Technical Service Bulletin: tsb100482

Released Date: 09-Aug-2006

New Lubricating Oil Pump with Integrated Pressure Relief Valve

New Lubricating Oil Pump with Integrated Pressure Relief Valve

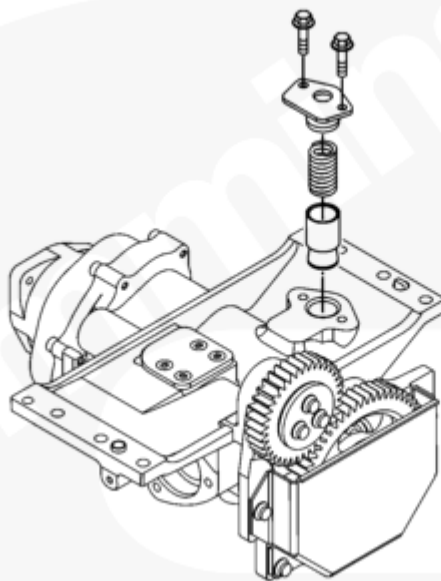
This Technical Service Bulletin introduces a redesigned lubricating oil pump with an integrated pressure relief valve.

This new lubricating oil pump will reduce oil pressure spikes during cold weather start up.

When a lubricating oil pump is replaced in the field, the new lubricating oil pump with the integrated pressure relief valve **must** be used. A temporary repair practice (TRP) will soon authorize the field to install the new lubricating oil pump when an oil filter failure occurs.

The new lubricating oil pumps, obsoletes and supersedes **all** of the old lubricating oil pumps. The remaining inventories of the old lubricating oil pumps have been scrapped.
